TYPICAL SECTIONS, MISCELLANEOUS DETAILS, LEGEND

ROUTE	SECTION	COUNTY	TOTAL SHEETS	SHEET NO.	
	08-00059-00-RP	CONTRACT !	39 un <b>QQ3</b> (	<u>ی</u>

PROPOSED TYPICAL SECTION:

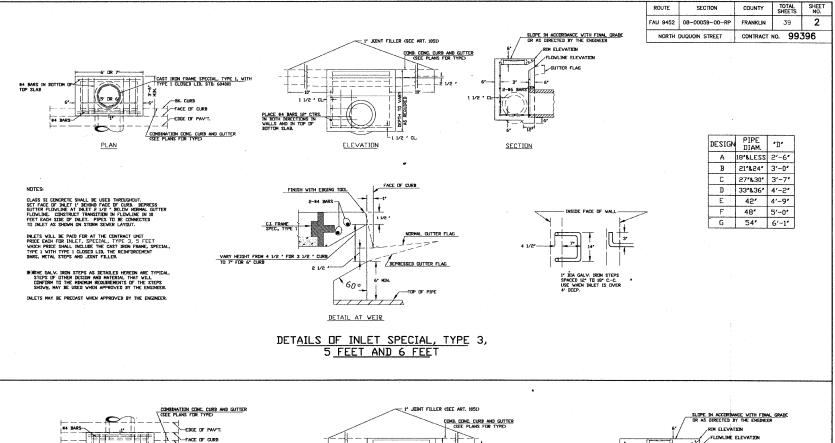
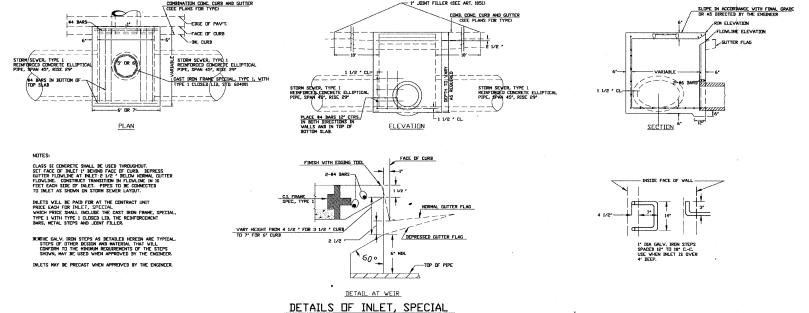
### △ Revised 2-10-10

CLASS IX STREET
DESIGN PERIOD, 20 YEARS
STRUCTURAL DESIGN TRAFFIC (S.D.T.) YEAR 2030 - 1,230
P.V. 1,165 S.U. 50 M.U. 15
